**Mount Owen
Continued Operations Project**
MODIFICATION 2

RESPONSE TO SUBMISSIONS

December 2018

Figure 6.1 Proposed Modification – Predicted annual average PM₁₀ concentrations in Camberwell (Property ID 152) from all approved nearby mine sources

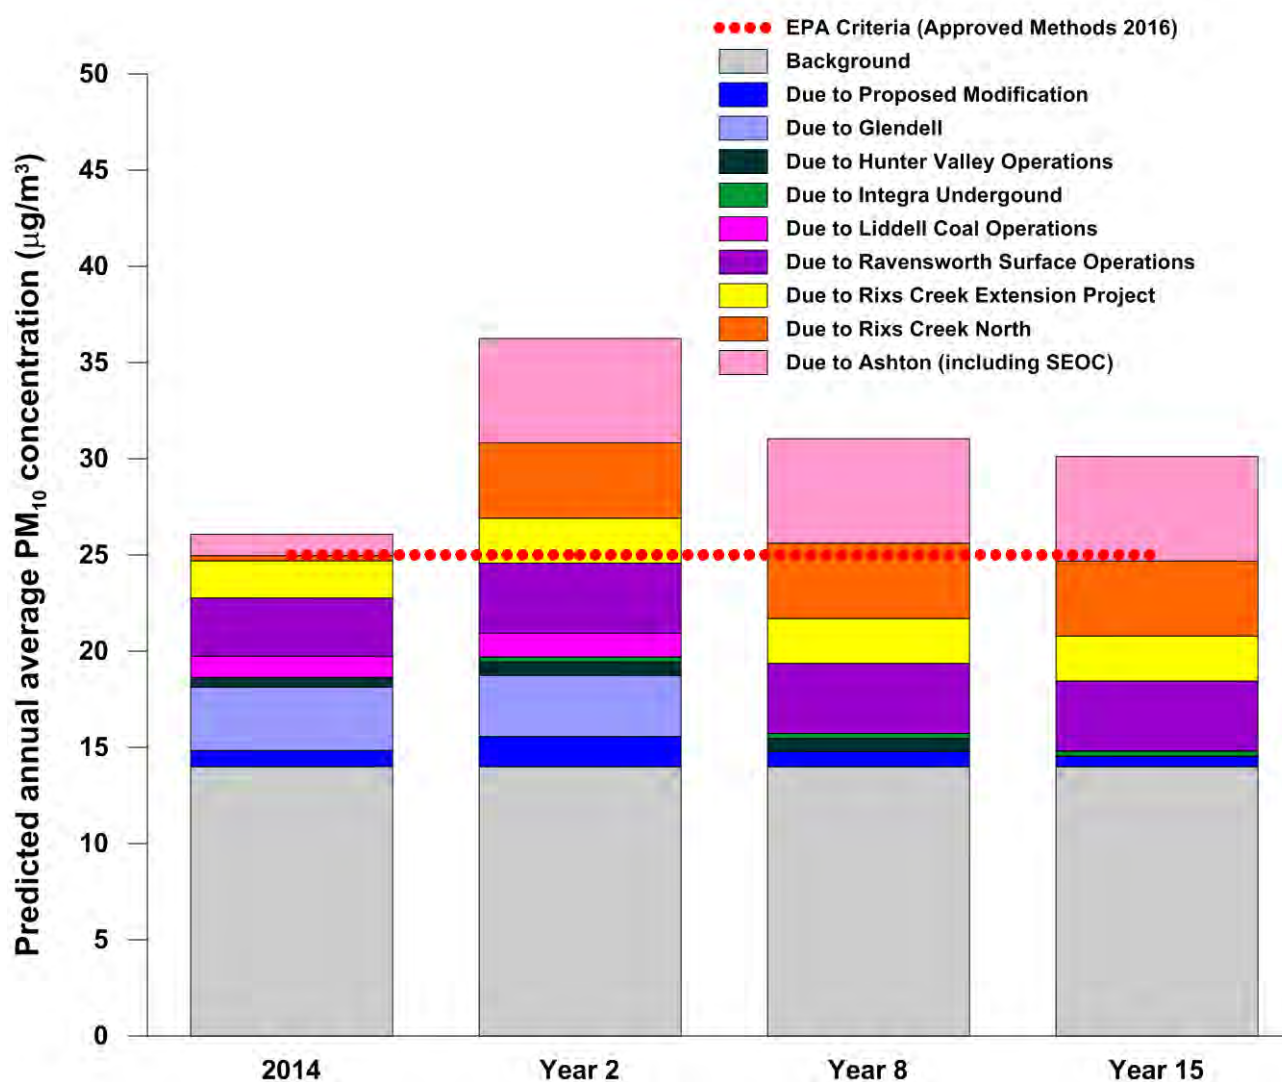
In particular, the AQIA should provide an assessment of cumulative PM₁₀ and PM_{2.5} concentrations in the event that the Ashton South East Open Cut Project does not proceed.

The proportional contributions of the various mining operations to particulate matter concentrations in the Camberwell area have been examined by extracting results from the model described in the AQIA (Jacobs, 2018). Specifically, the predicted annual average PM₁₀ concentrations at property 152, located in the centre of Camberwell, have been collated for all years of assessment for the Proposed Modification and for all source contributions including background levels (refer to **Figure 6.1**). Annual average PM₁₀ has been selected for this assessment given that concentrations of this particulate matter classification have historically approached or exceeded the recently introduced EPA criterion of 25 µg/m³ in the Camberwell area (refer to Figure 9 of the AQIA).

The annual average PM₁₀ contribution from the Proposed Modification at Camberwell is predicted to be less than 2 µg/m³ in the worst case year. This value reflects the distance and direction of the Mount Owen and Ravensworth East Mines relative to Camberwell and is consistent with the predicted contributions associated with the Approved Operations (refer to Table D2 of Appendix D in PEL 2014). It can be seen from **Figure 6.1** that emissions from the Proposed Modification would not be the main contributor to annual average PM₁₀ concentrations at this location. It should also be noted that the modelled cumulative PM₁₀ levels are predicted to exceed the recently introduced 25 µg/m³ EPA annual average criterion in Year 2, Year 8 and Year 15 (should the Ashton SEOC Project commence) without the contribution from Mount Owen, either the Approved Operations or the the Proposed Modification.

FIGURE 6.10
 Proposed Modification
 Conceptual Final Landform

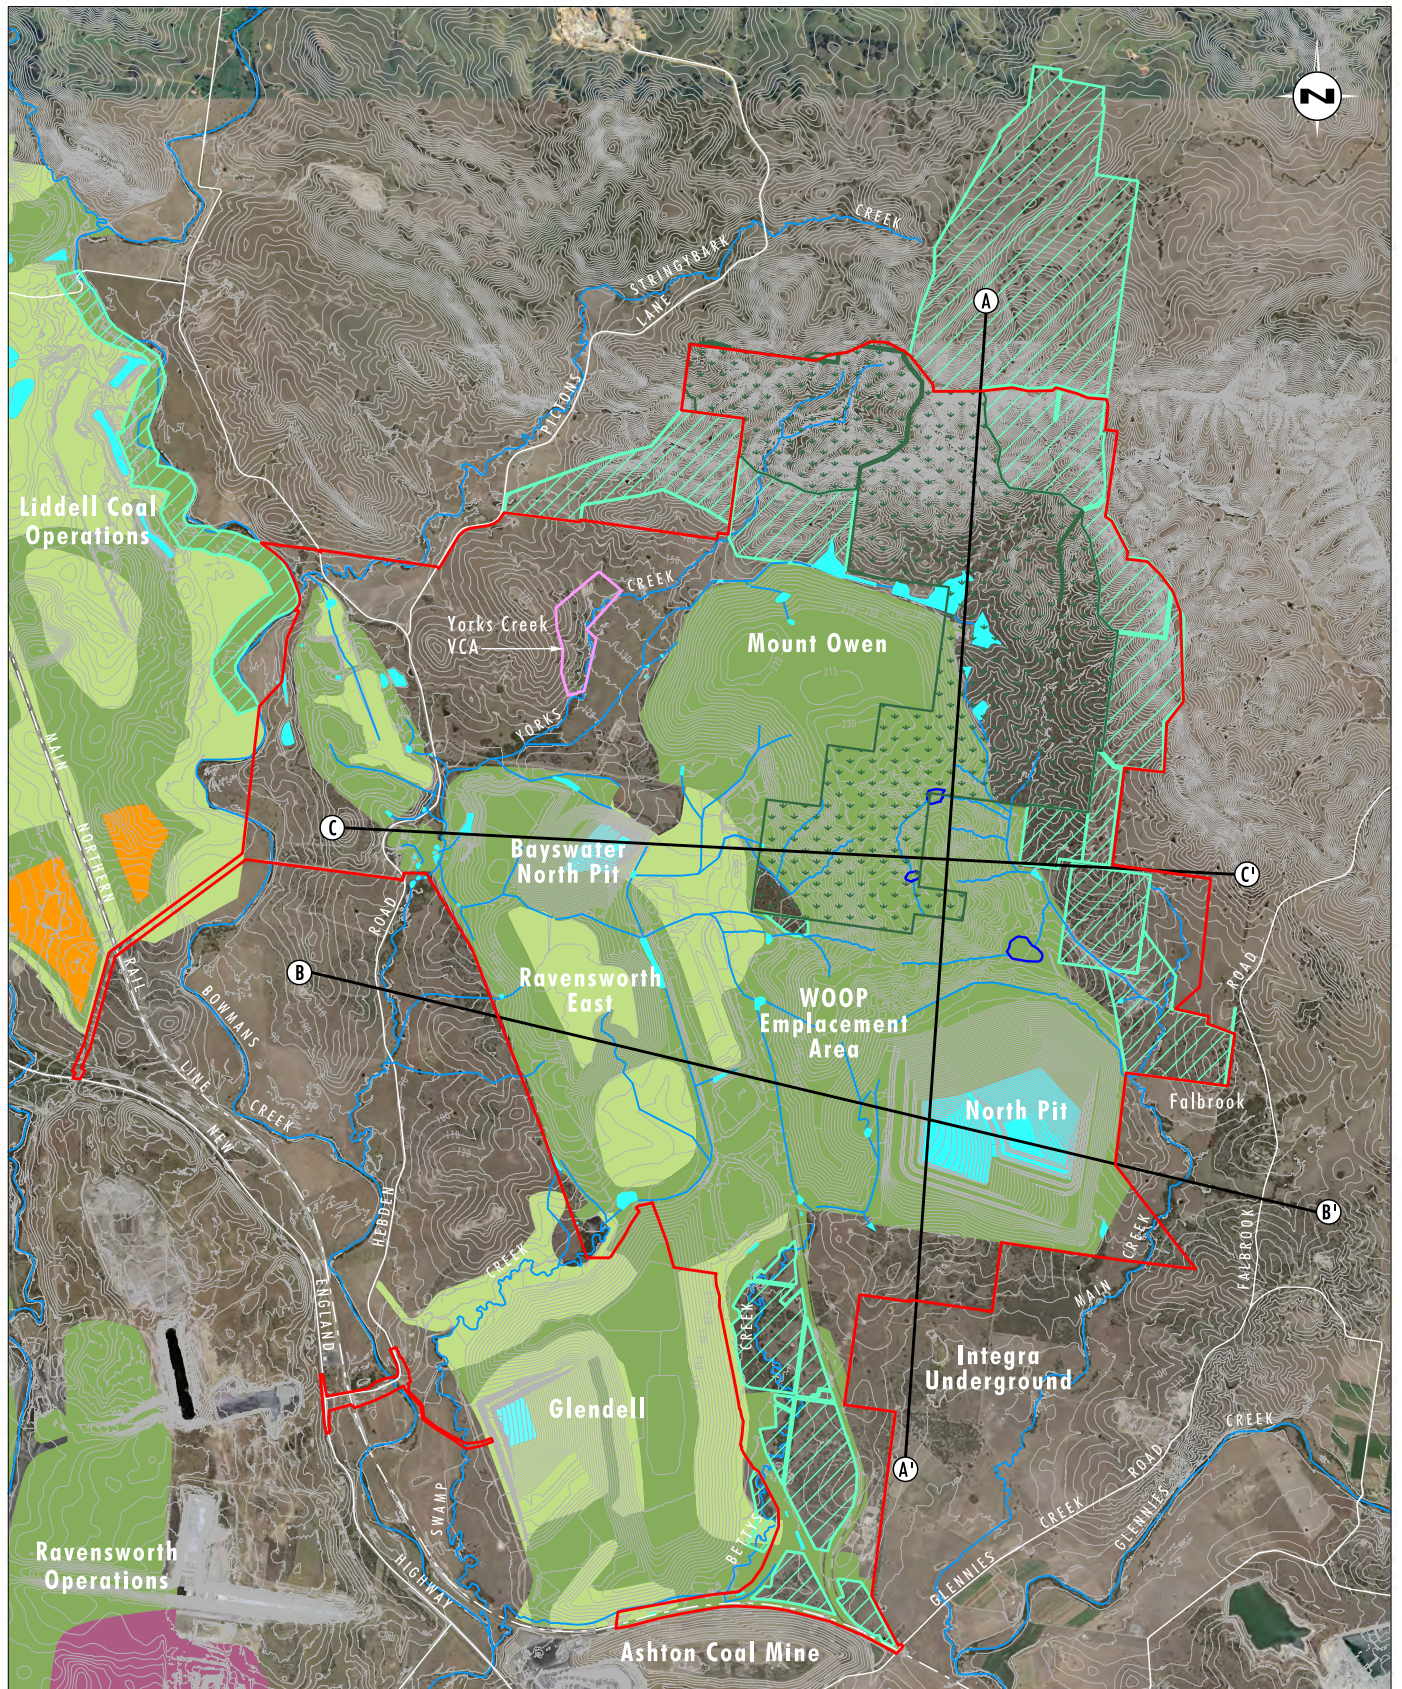
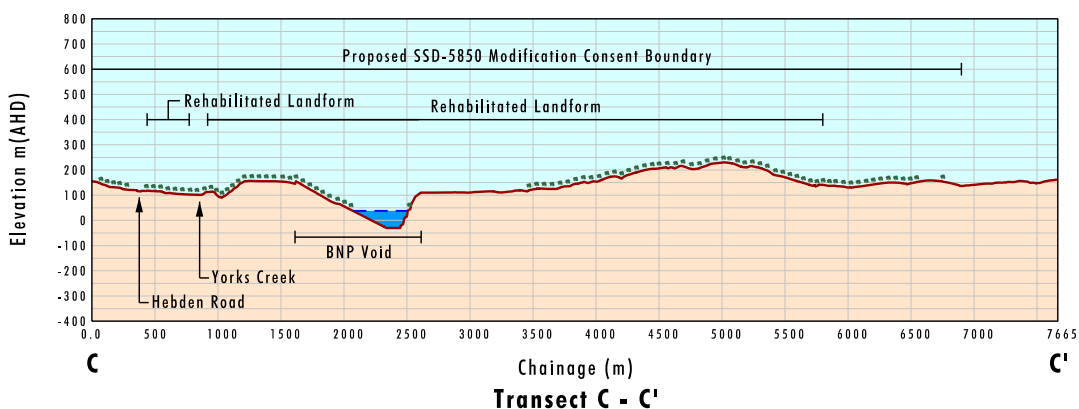
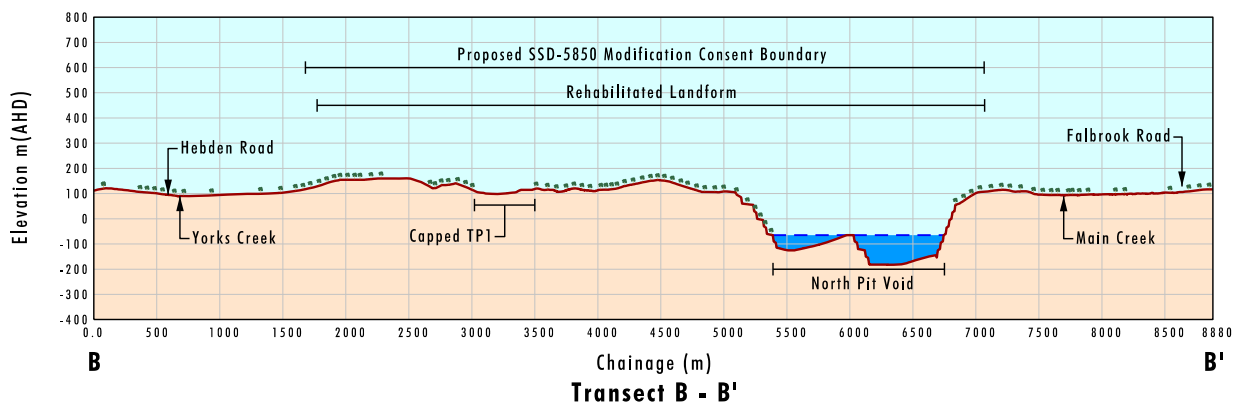
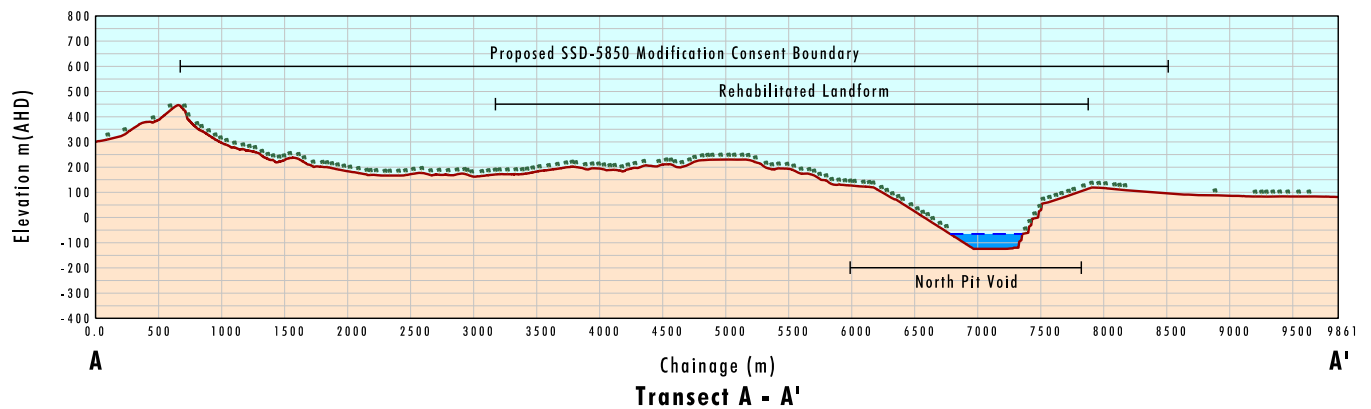
The transects in Figures 2.6 and 2.7 of the SEE do not have any corresponding reference point on Figure 2.5. Please clarify.

Figure 2.5 from the SEE (reproduced below as **Figure 6.10**) has been updated to include the corresponding transect lines to Figure 2.6 from the SEE (reproduced below as **Figure 6.11**). Figure 2.7 from the SEE (reproduced below as **Figure 6.12**) provides an indicative north-south and east-west conceptual comparison focused on the North Pit final void. The transect does not have a corresponding reference point and has been prepared to illustrate that the key difference between the approved and proposed conceptual landforms is the deeper final void associated with the Proposed Modification.
